Outer Dowsing Offshore Wind Farm

Appendix C7 to the Natural England Deadline 6 Submission
Natural England's Advice on Benthic Ecology

Planning Inspectorate Reference EN010130

4th April 2025

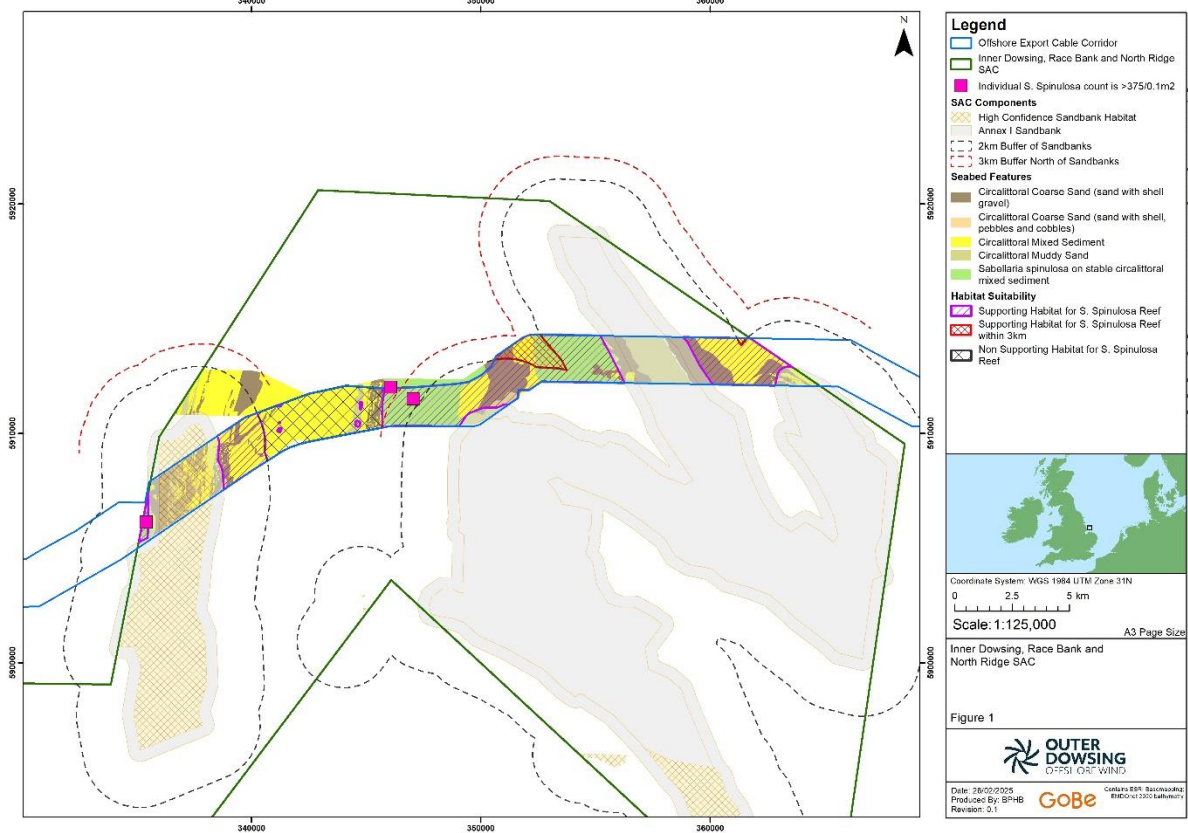
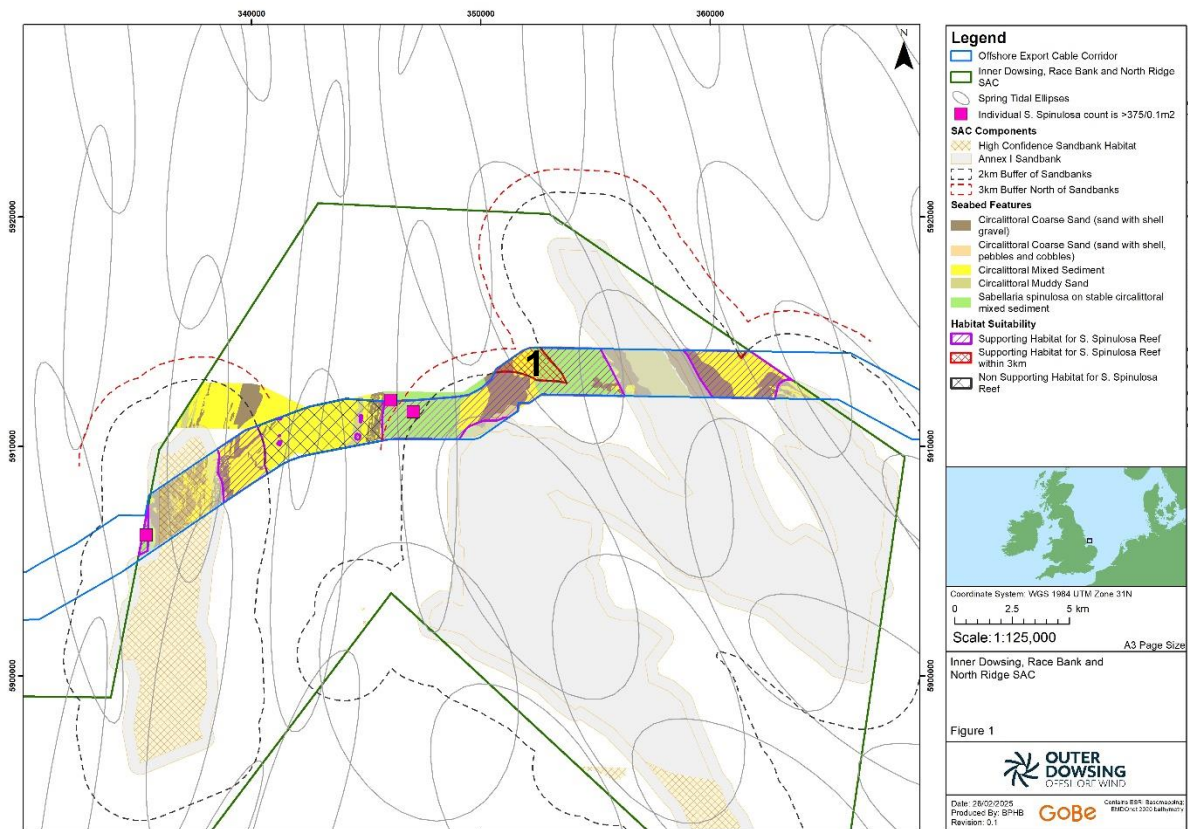
- 1. NE previous advice: Table 2, optional parameter 1 – It is not clear if this parameter has considered dominant direction tidal flows which would require an increase in the buffer from 2km to 3km. The figures in ‘Chapter 7 Marine Physical Processes Figures Part 1 of 2’ demonstrate that the dominant tidal flows and bedload transport across the ECC are in the NNW and SSW directions, and as such, we advise that the 2km buffers applied should be extended to 3km to align with the description of optional parameter 1 within the Technical Note.**

Natural England welcomes the addition of the 3km buffer to the north of the sandbank features. While this satisfies our previous advice; to ensure joint understanding of the approach, we highlight that according to the methods outlined within the Applicants [*Sabellaria spinulosa* reef supporting habitat Technical Note: February 2025], much of the red cross hatch area which we have annotated with number ‘1’ below should have been already included as supporting habitat owing to the presence of the ‘SS.SBR.PoR.SspiMx - *Sabellaria spinulosa* on stable circalittoral mixed sediment’ which has been mapped in that location (in alignment with optional parameters 2 and 4).

2. ***NE previous advice: In addition, for the avoidance of doubt, Figure 1 of the report should be updated and areas of Annex I sandbank delineated as potentially supporting habitat to Annex I Sabellaria spinulosa Reef (i.e. using the purple hash) included/differentiated.***

3. ***NE previous advice: Table 2, optional parameter 2 and 4 – Natural England advises that were this parameter to be appropriately applied to the data presented in Figure 1, then all areas of the SS.SBR.PoR.SspiMx biotope (including that outside of 2km sandbank buffer) should have been included as supporting habitat for Annex I Sabellaria spinulosa Reef.***

4. ***NE Previous Advice: In addition, Figure 1 does not appear to include all areas that were identified as SS.SBR.PoR.SspiMx within the Offshore Export Cable Corridor Sabellaria Spinulosa Reanalysis and Report Date: December 2024 Document Reference: 15.13 V2 Revision: 2.0 and labelled as “Figure 2. Marine habitat map at Level 4 MNCR for the Project ECC, produced using project specific data from the most recent benthic habitat surveys (ENVISION, 2024).”***

ODOW response: The Applicant notes difficulty in interpreting ‘Optional parameter 1,’ specifically the phrasing: “*within 2 km of sandbanks in any direction OR within 3km in the direction of tidal stream, whichever is the greater* 2.” Our initial interpretation was that the worst-case area for the majority of the Offshore ECC was ‘within a 2 km radius of the sandbanks’. This interpretation arose due to the direction of the tidal stream (approximately NW-SE/ N-S, see Figure below which presents tidal ellipses), we therefore did not anticipate that this would have a greater impact on the width of the corridor than the 2 km buffer applied around the entire sandbank.

Furthermore, there was additional confusion surrounding the phrase “OR within 3km in the direction of tidal stream,” as it does not clearly state what the 3km buffer is associated in relation to the tidal stream – we assume that this would be the northern points of the sandbanks for the current features of interest. We have mapped the tidal ellipse data (see figure below), which demonstrates that a 3 km buffer could be applied to the north of the sandbank features, specifically “in the direction of tidal stream.” This would result in two small areas highlighted by the red cross hatch in the figure below being included as supporting habitat. This additional area is 2.5km². As illustrated in the figure, no other additional adjustments in relation to ‘Optional parameter 1’ are necessary.

ODOW Response: The Applicant notes that this area has now been included as supporting habitat for Annex I *Sabellaria spinulosa* Reef as demonstrated in the Figures above, when applying the 3 km buffer to the north of the middle sandbank feature.

ODOW Response: The Applicant notes that there is no figure labelled “Figure 2. Marine habitat map at Level 4 MNCR for the Project ECC, produced using project specific data from the most recent benthic habitat surveys (ENVISION, 2024)” however, the Applicant has applied the SS.SBR.PoR.SspiMx biotope that has been identified across all figures within this report. Most of these areas correspond with the site-specific data [APP-155], however 4 discrete patches have been identified and included in the supporting habitat for *S. spinulosa* reef area, as identified in the Figures above.

Natural England uphold our previous reference to “Figure 2. Marine habitat map at Level 4 MNCR for the Project ECC, produced using project specific data from the most recent benthic habitat surveys (ENVISION, 2024i)” which exists within [REP4a-070]. However, we are now satisfied that optional parameter 2 has now been met and that areas which have been previously identified as SS.SBR.PoR.SspiMx biotope have now also been included as supporting habitat.
